Our Ref: 53469LET03

Response to RFI #2 - Application ID 24029819 at 162 - 168 Gouger Street, Adelaide

MasterPlan act for the applicant, Square Mile Properties Pty Ltd, in respect of Development Application ID 24029819 for the construction of a mixed-use building up to 16 levels in height, comprised of 107 dwellings with podium car parking and three ground-level shops at 162 – 168 Gouger Street, Adelaide.

Figure 1: Cleanaway Waste Truck Diagram.

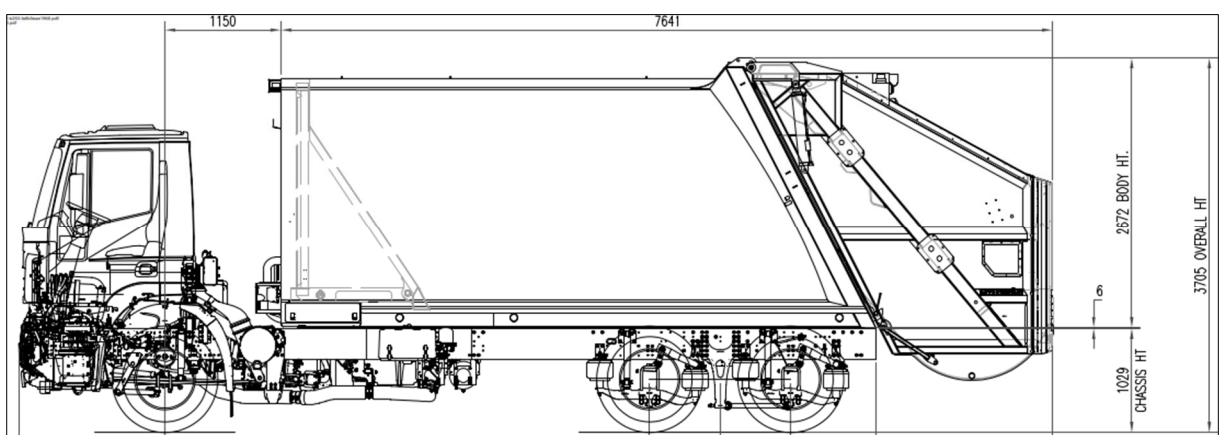
Further advice has been sought from Colby Phillips Advisory, who have provided three examples of the most common waste trucks utilised by private collection services operating in metropolitan Adelaide, comprising:

- Cleanaway future standard with 3.7-metre height (refer **Figure 1**).
- JJ Richards & Sons standard with 3.4-metre height (refer **Figure 2**).
- Remondis future standard with 3.04-metre height (refer **Figure 3**).

Whilst we consider that the clearance previously proposed accommodates all three of the dimensioned waste truck examples which are typical used to service these developments, in order to resolve the issue and conclude this request the waste room clearance has been increased to 4.0 metres. The roller door clearance height has been increased to match. This change is demonstrated in the accompanying Updated East and North Elevations (Drawing TP201), prepared by Bibbo Architects.

The waste loading dock has a total clearance of 4.6 metres to the underside of the slab. This height can therefore accommodate services to the underside of the slab whilst still achieving the 4.0-metre internal clearance requested in the RFI. This 4.0-metre clearance will accommodate 100 per cent of all rear-lift trucks operating in Adelaide.

STREET TREE PLAN

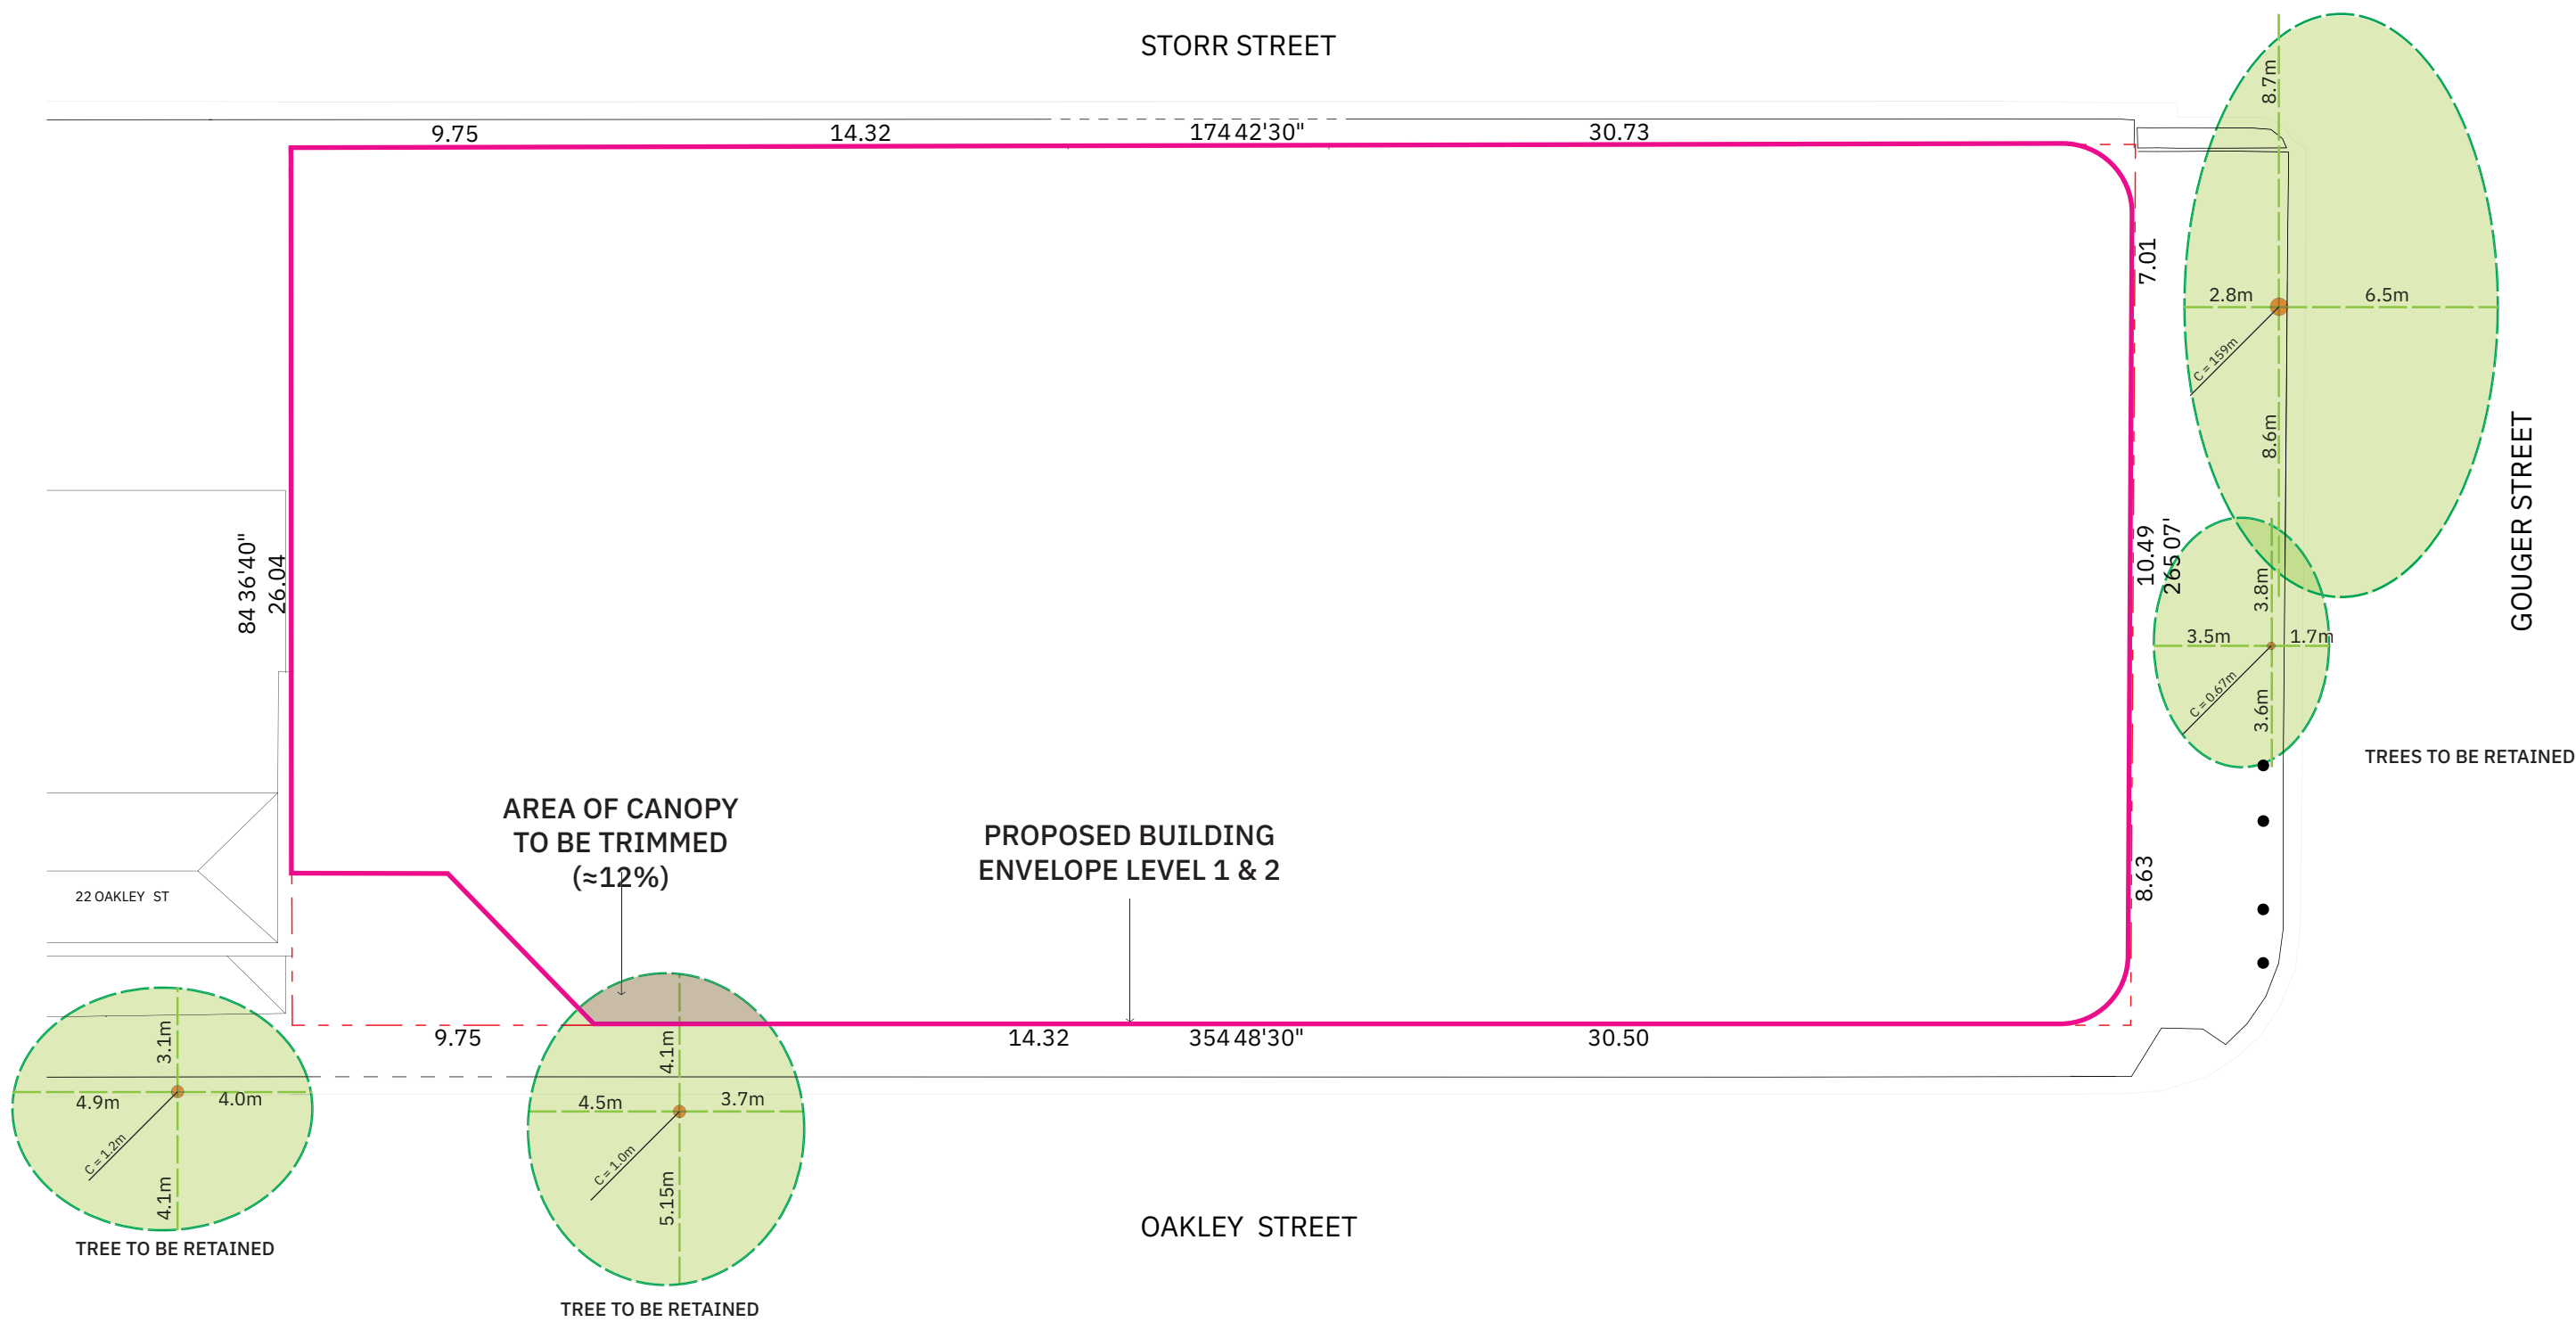
The two trees located on Oakley Street (including the species north of the site) are Honey Locust trees, an exotic species. Both of these species meet the definition of Regulated Tree under the PDI Regulations.

Neoxena's advice indicates the only tree that would be affected by the proposed works would be "tree 3", the Honey Locust tree on the Oakley Street site frontage. As previously demonstrated, there will be some minor pruning required of the canopy which encroaches into the subject land. Neoxena has determined that the extent of pruning required will be no greater than 12.0 per cent of the canopy, less than the 15.0 per cent previously estimated. This does not qualify as tree damaging activity.

Neoxena's advice also indicates that the development is unlikely to impact upon the structural root health of the subject trees as per the structural root and tree protection zones determined in the accompanying Tree Assessment Report.

As such, no tree damaging activity is proposed.
